CUSTOMER SATISFACTION NOTIFICATION

Serpentine Belt Squeal

Reference: 47A

2022 - 2023 (RU) Chrysler Pacifica/Voyager

Figure 6 – Belt Tensioner

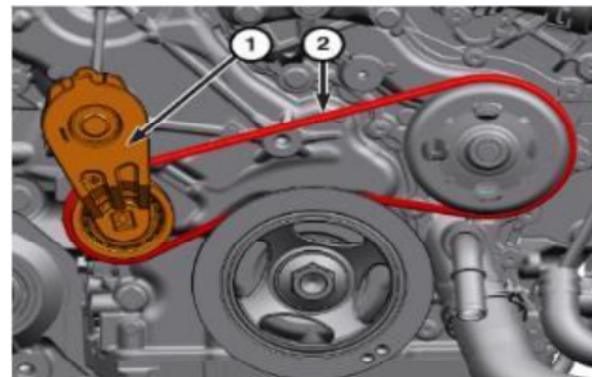
6. Rotate the belt tensioner (1) until it contacts its stop (Figure 6).
7. Remove the serpentine belt, then slowly rotate the tensioner into the free position.

Figure 7 – Serpentine Belt Routing

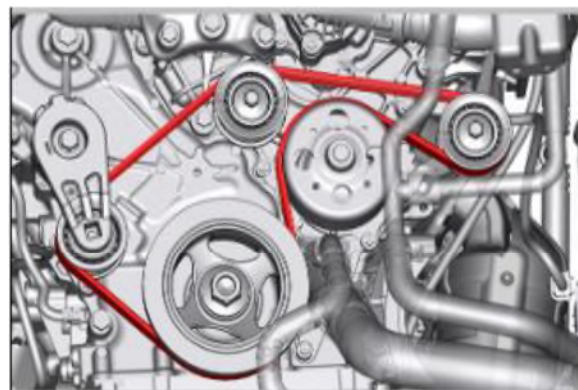
The serpentine belt on about 8,342 of the above vehicles may squeal due to insufficient belt to pulley contact.

Install the idler pulleys, tensioner, and a new serpentine belt.

8. Remove the serpentine belt and **DISCARD**.
9. Install the left idler pulley onto the front center of the engine and tighten the bolt to 24N·m (18Ft. Lbs.) (Figure 7).

10. Install the right idler pulley bracket onto the right side of the engine and tighten the bolt to 24N·m (18Ft. Lbs.) (Figure 7).
11. Install the right-side idler pulley and tighten the bolt to 24N·m (18Ft. Lbs.) (Figure 7).

12. Install the **NEW** belt tensioner and tighten the bolt to 55N·m (41Ft. Lbs.).
13. Route the **NEW** serpentine belt around all the pulleys except the idler pulley (Figure 7).

NOTE: When installing the serpentine accessory drive belt, the belt MUST be routed correctly. If not, the engine may overheat due to the water pump rotating in the wrong direction.

14. Rotate the belt tensioner until it contacts its stop position. Route the serpentine belt around the idler and slowly let the tensioner relax. Make sure the belt is properly seated onto all pulleys (Figure 7).
15. Measuring from the AC compressor electrical connector install the High Voltage (HV) wire harness clips on to the harness and attach them to the idler pulley bracket as shown in (Figure 8).
